Docket No. 50-466

Allens Creek Nuclear Generating Station Unit 1

Amendment 53 to the  
PSAR

Amendment 53 consists of additional PSAR information updating the PSAR since the issuance of the Allens Creek Safety Evaluation Report, Supplement 2.

HYDROGEN CONCENTRATION IN THE  
DRYWELL (WITHOUT BLOWER ACTIVATION)  
.85% METAL-WATER REACTION  
FIGURE 6.2-28a

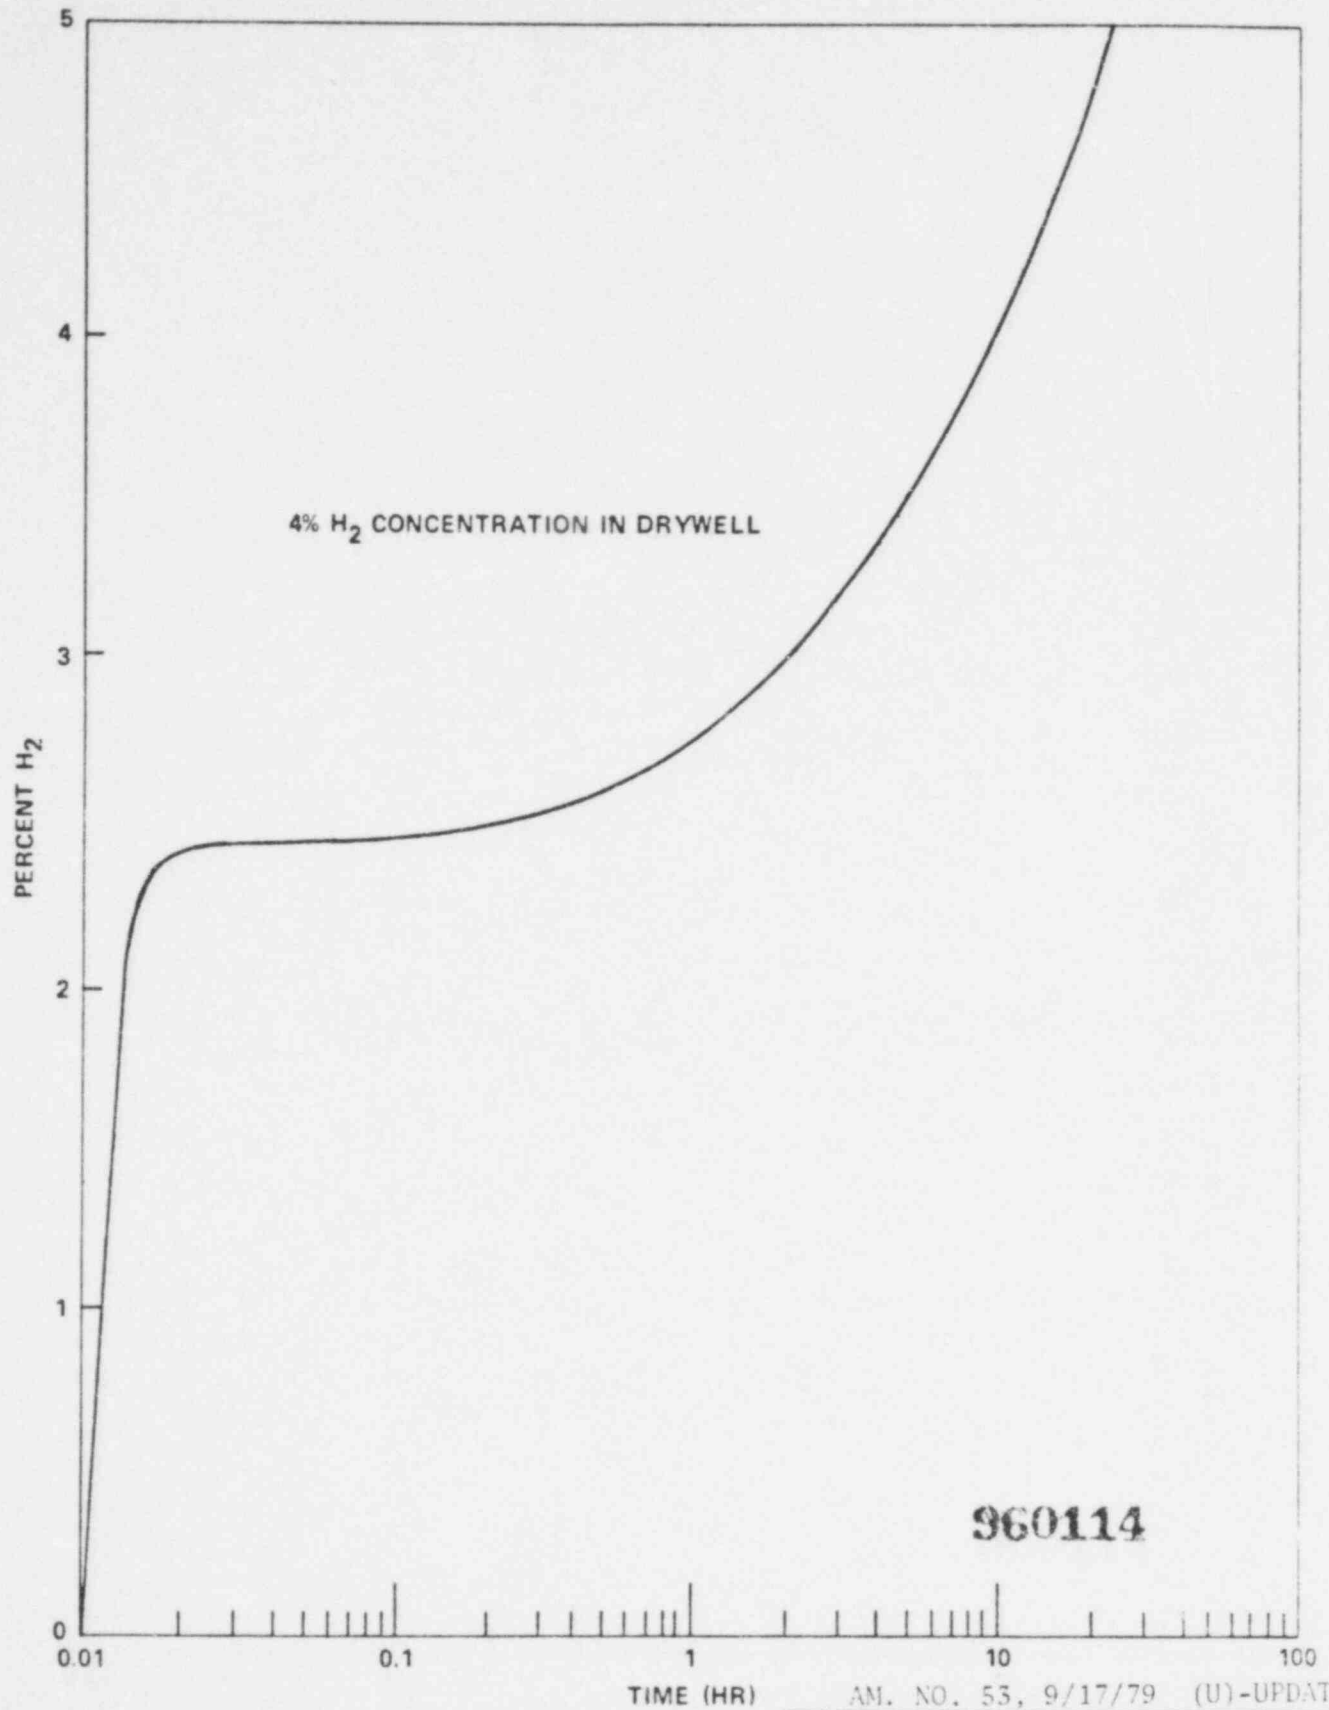
Figure 6.2-28a shows drywell hydrogen concentration as a function of time based on the assumptions listed below. Based on these assumptions, it is calculated that the control limit (4%) would be reached in the drywell approximately 8 hours after the LOCA.

The transient hydrogen concentration curve shown in Figure 6.2-28a is based upon a non-condensable air pressure of 14.7 psia and a drywell air volume reduced by water flooding up to the top of the weir wall. This quasi steady state condition is conservatively assumed to exist immediately following the hypothesized metal-water reaction at LOCA + 2 minutes. This takes no credit for steam purging of the drywell or steam dilution due to pressure increase in the drywell. In a more realistic sequence, the

FIGURE 6.2-29 960116

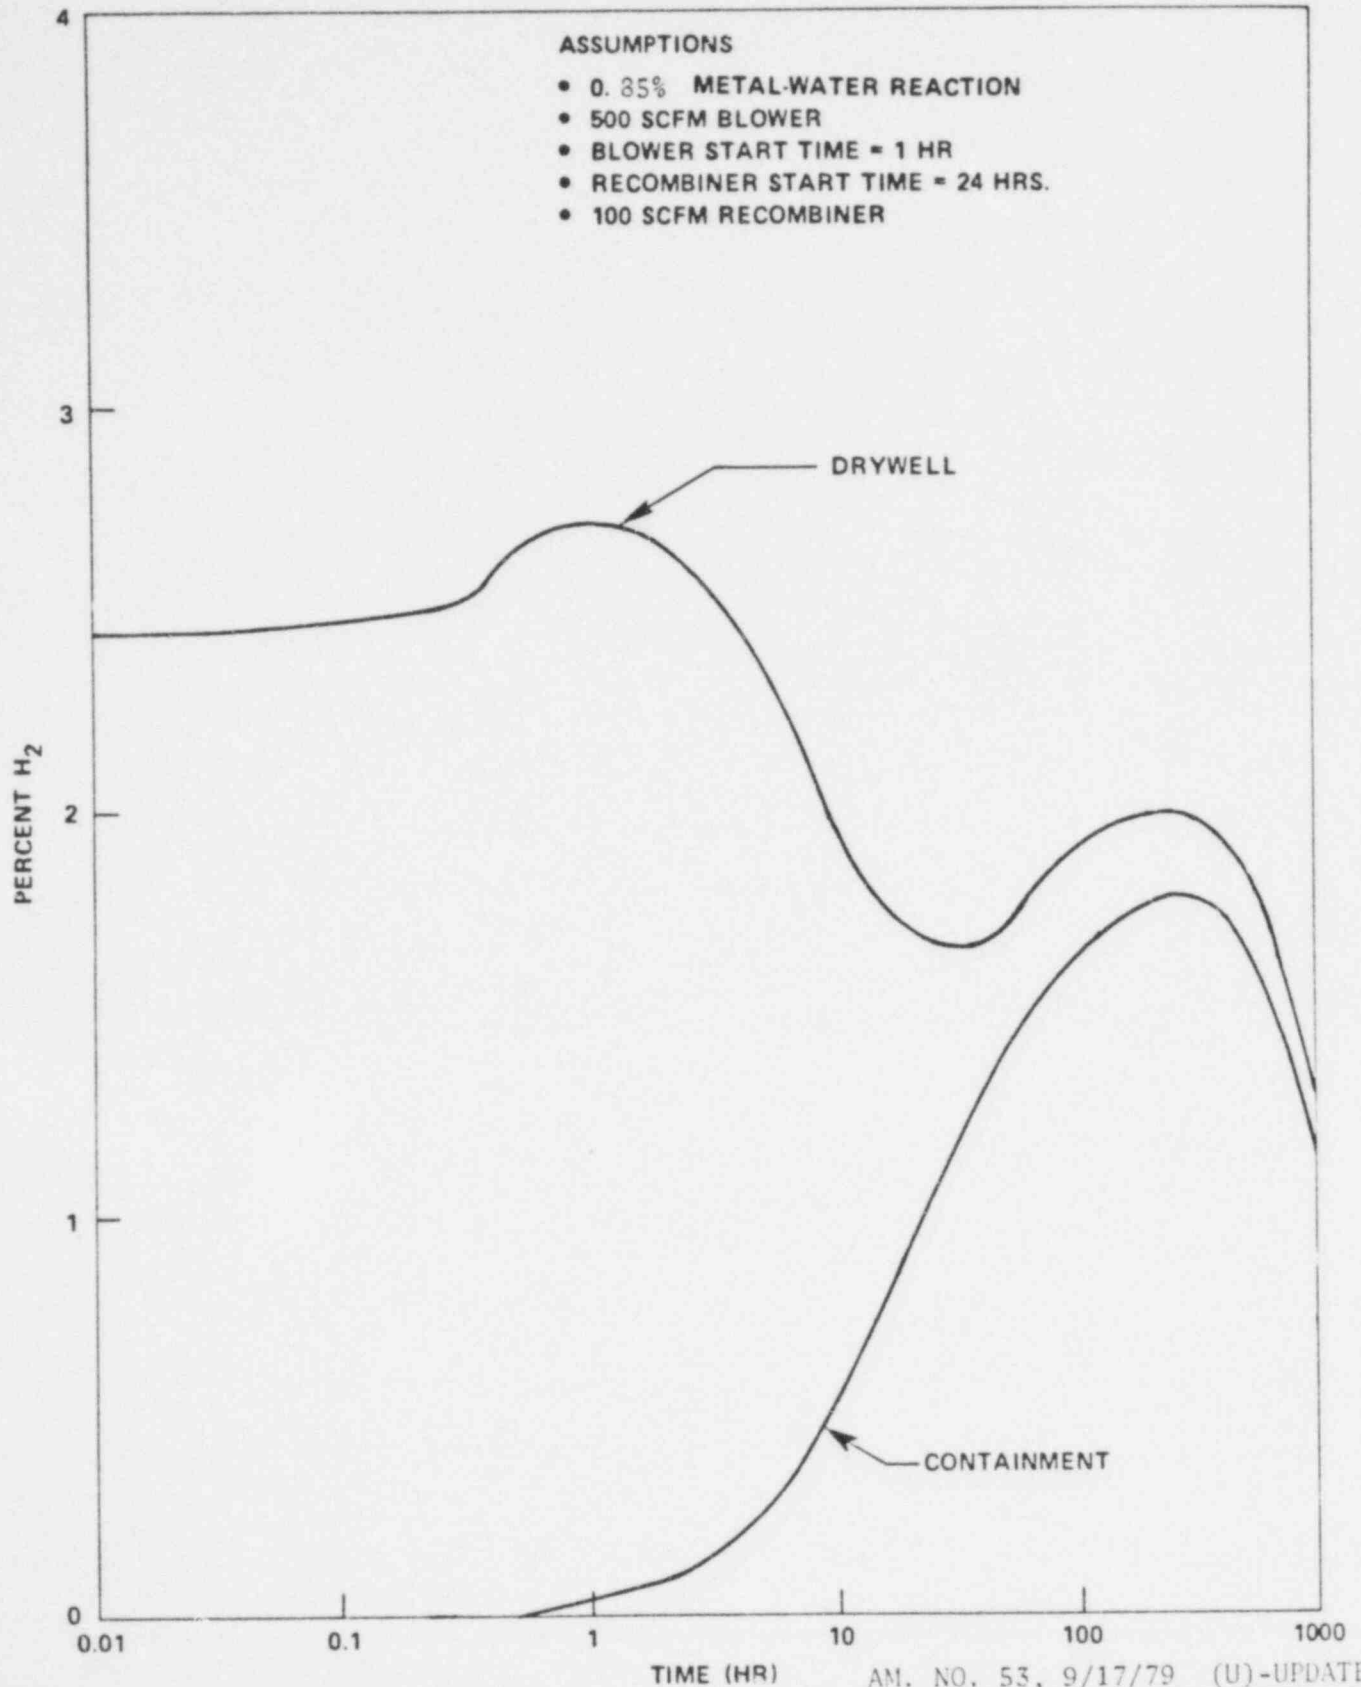
The calculations indicate that actuation of the Drywell Hydrogen Control System causes an immediate decrease in the drywell hydrogen concentration. (See Figure 6.2-29). The recirculation of the Containment atmosphere causes the hydrogen concentration to become uniform throughout the Containment and drywell.
